UNITED STATES PATENT AND TRADEMARK OFFICE

10/560,411

Office Action Summary	Application No. 10/560,411	Applicant(s) OEHMANN, ROLAND	
	Examiner Vinod D. Patel	Art Unit 3742

Fig. 5

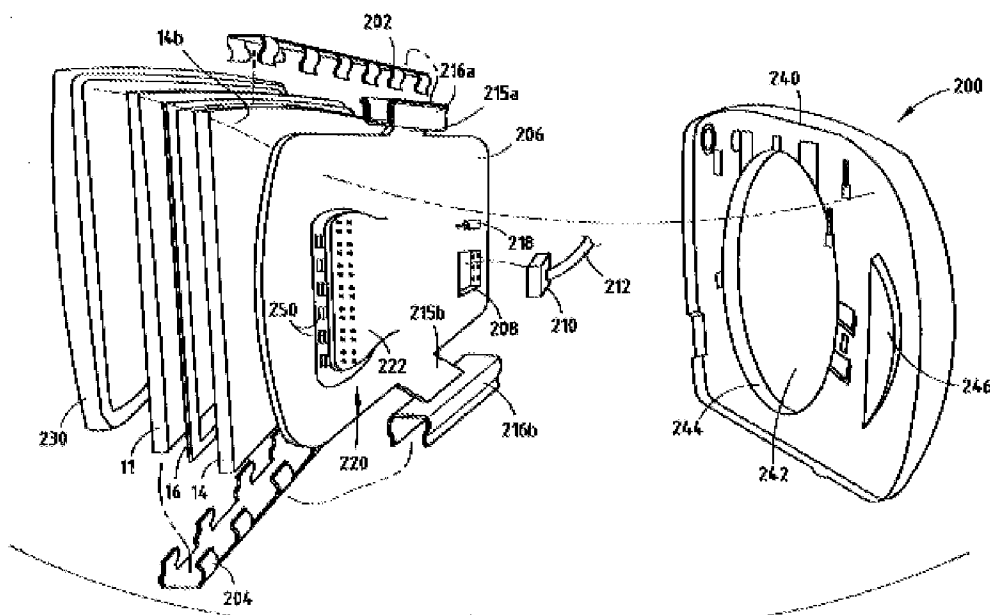
With respect to claim 1, Bonardi et al. discloses a vehicle outside mirror module (200) with a heatable mirror glass assembly group, whereby the mirror glass assembly group (10) exhibits at least one mirror glass (14) and an at least one layered, foil-like heating foil (206) flexibly configured on the back side (14b) of said mirror glass provided with power supply points (208) - said heating foil receiving at least one heating element thus characterized, - that on or in the heating foil (206) at least one means of lighting (220) and at least one additional power supply point (paragraph[0053]) are configured or integrated, - that on or in the heating foil (206), between the one or the several lighting means (220) and the one or the additional power supply points (paragraph[0053]), conductive tracks providing current are configured or integrated which contact said power supply points, - that each lighting means has at least one main light exit surface whose spectral centroid lies above the mirror back surface (paragraph [0053]).

With respect to claim 4, the mirror glass is clamped in between a mirror glass support and a mirror glass frame, secured to said support, embracing the mirror glass on its front side as shown in Fig. 5.

With respect to claim 5, the mirror glass frame exhibits a ring-shaped hollow chamber leading along the edge of the mirror as shown in Figure 5.

With respect to claim 6, the tabs (215a) of the heating foil (206) equipped with the lighting means (220) are configured to have play or to exactly form-fit inside of the hollow chamber.
